CITY OF TAMPA

CONTRACT ADMINISTRATION DEPARTMENT

ADDENDUM NO. 1

Contract 14-C-00056; Harbour Island Roadway Surface Replacement

**REPLACEMENT
 PARTIAL PLANS
 SECTIONS A & B**

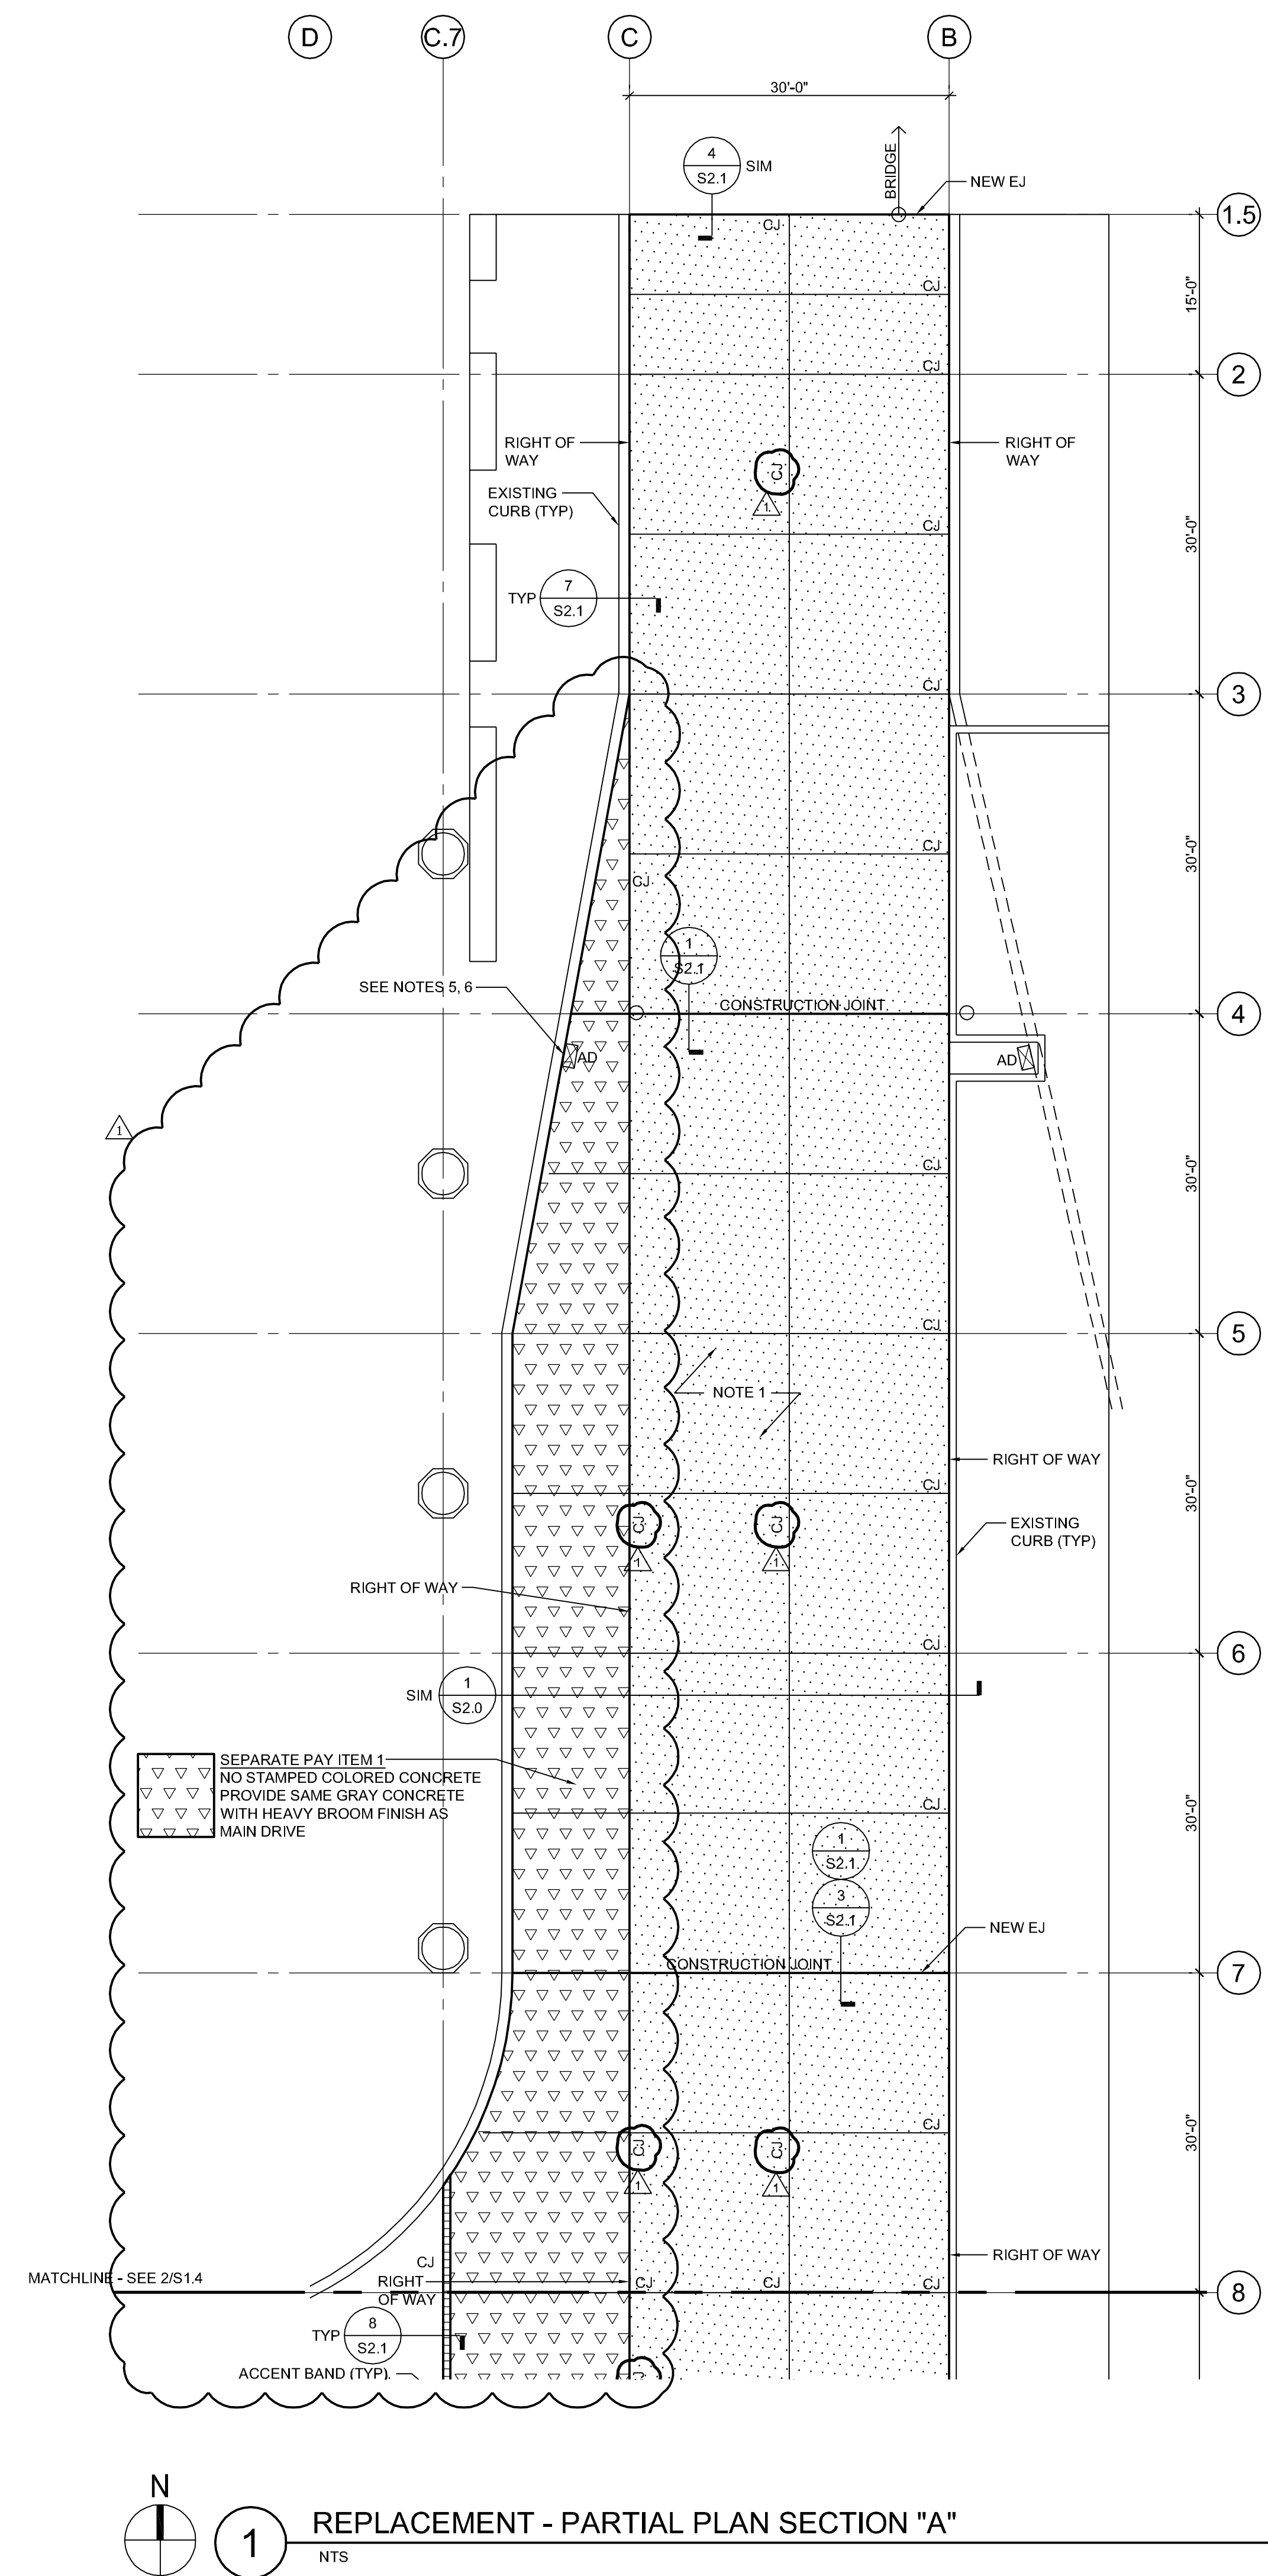
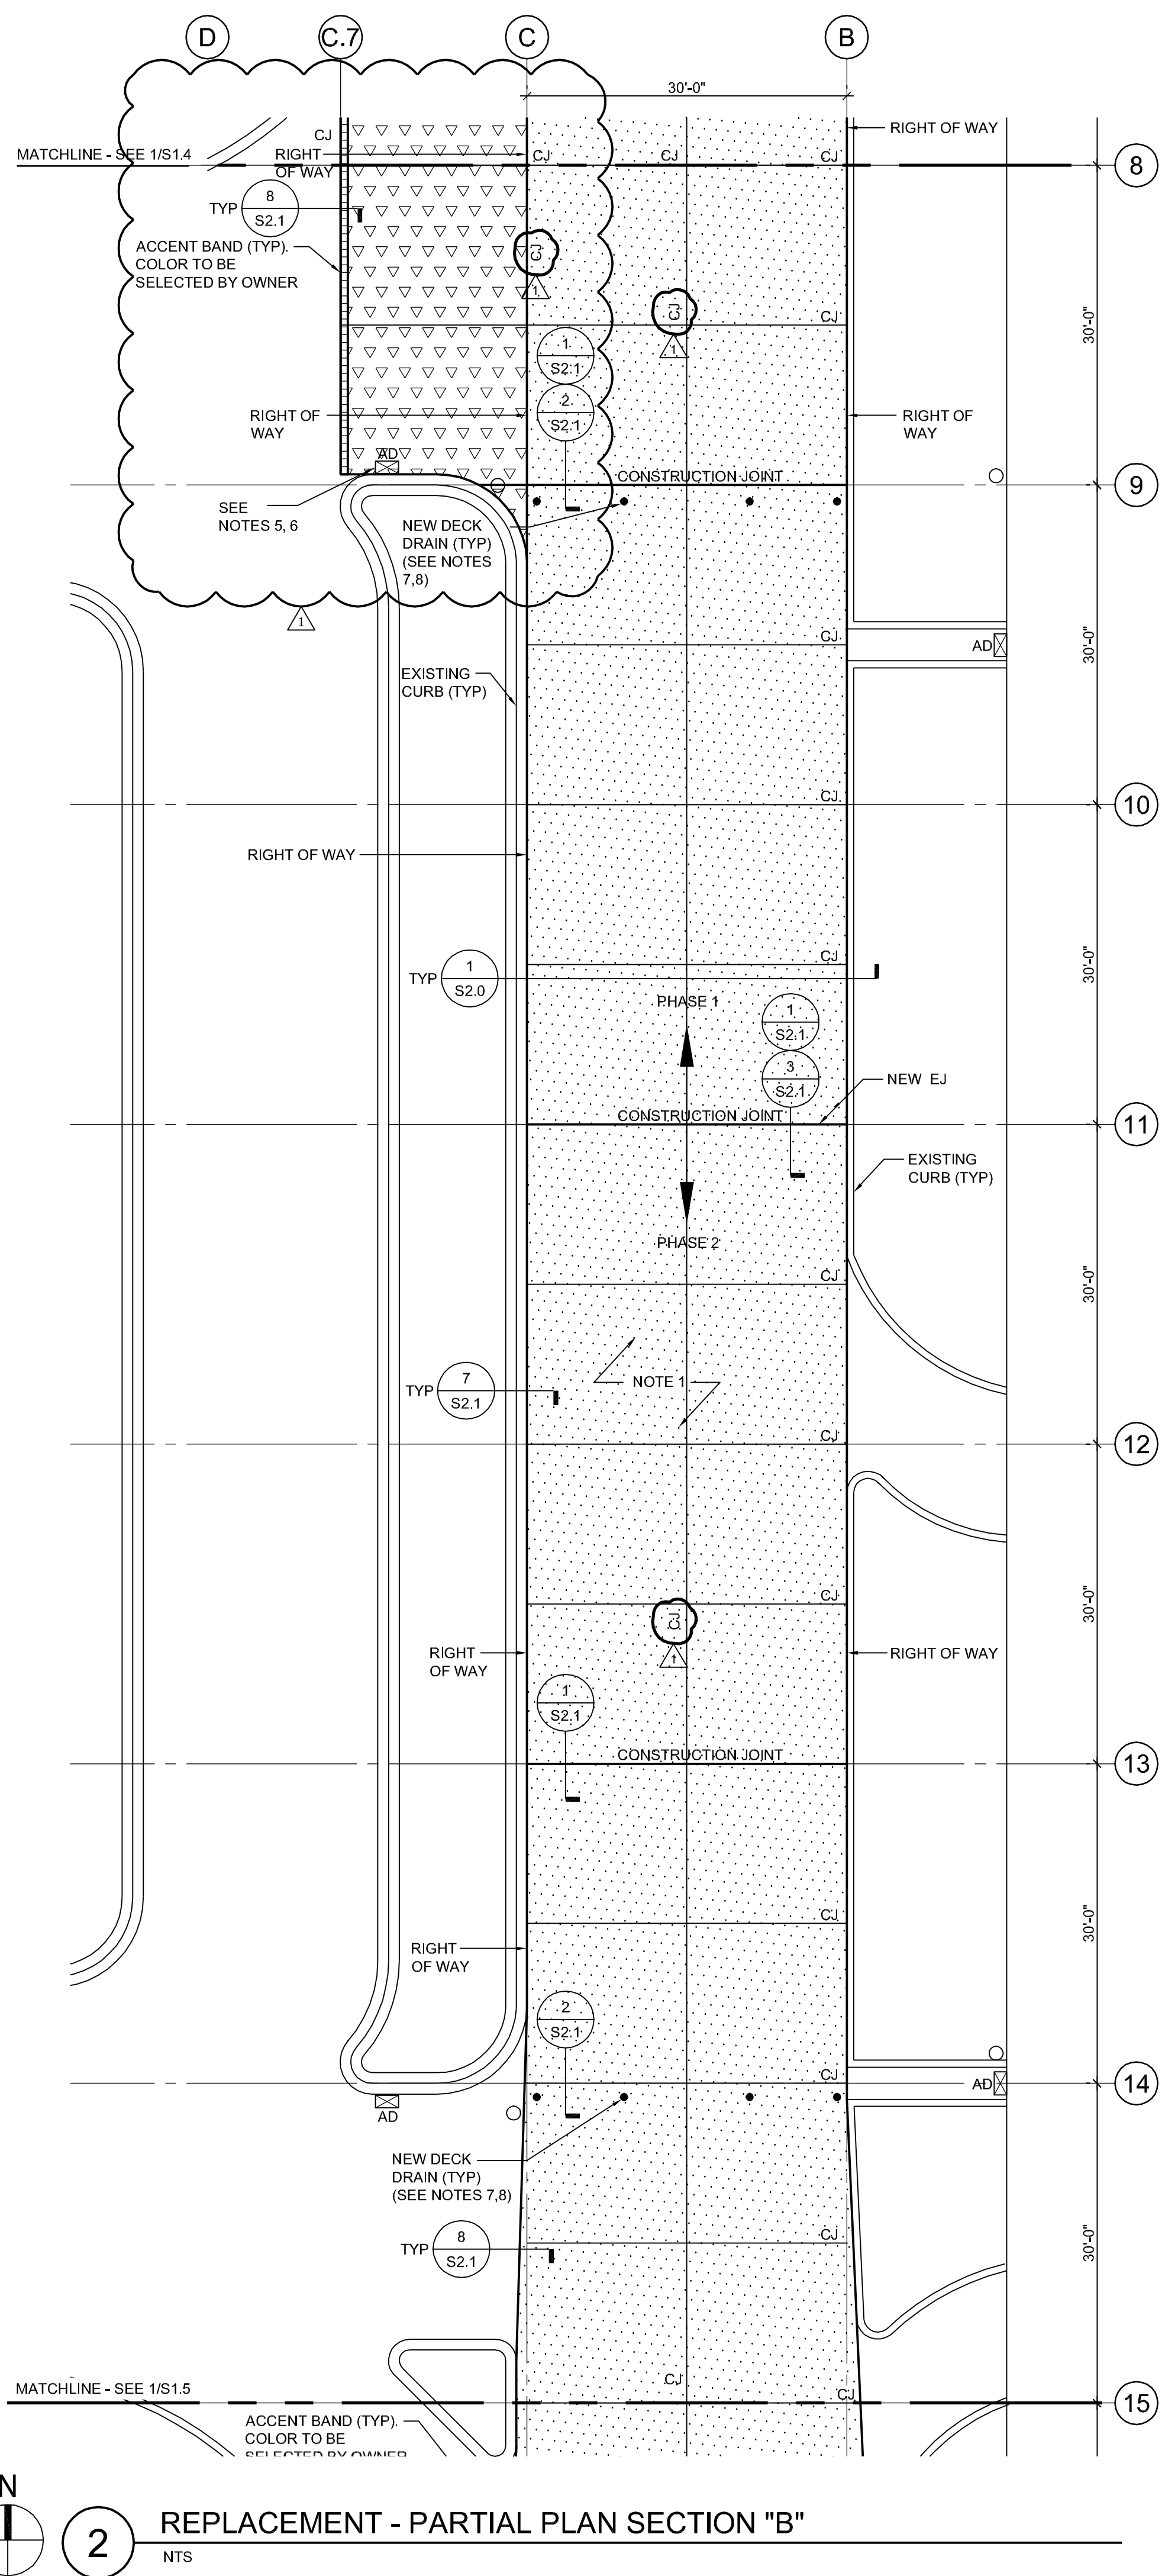
△ AESTHETIC SURFACE DESIGN REQUIREMENTS.
 1. ACCENT BAND TO BE PROVIDED BETWEEN EXISTING COLORED STAMPED CONCRETE AND ADJACENT PROPOSED UNCOLORED CONCRETE.
 2. EXISTING SPECIFICATIONS TO NOT BE RE-CONSTRUCTED.
 3. EXISTING PAVERS IN THE MEDIAN ARE NOT TO BE REPLACED. THESE AREAS WILL RECEIVE SPECIFIED CONCRETE TOPPING SLAB ONLY.
 4. BROOM FINISH ALL CONCRETE TOPPING SLAB FINISHES. REFER TO SPECIFICATIONS.
 5. CONTRACTOR SHALL PREPARE 2 FT BY 2 FT MOCKUP SAMPLE FOR EACH TYPE OF STAMPED AND/OR COLORED CONCRETE FOR CITY, HCSA AND ENGINEER APPROVAL PRIOR TO COMMENCING WITH PLACEMENT OF NEW TOPPING SLAB.

SEPARATE PAY ITEM 1
 NO STAMPED COLORED CONCRETE
 PROVIDE SAME GRAY CONCRETE
 WITH HEAVY BROOM FINISH AS
 MAIN DRIVE
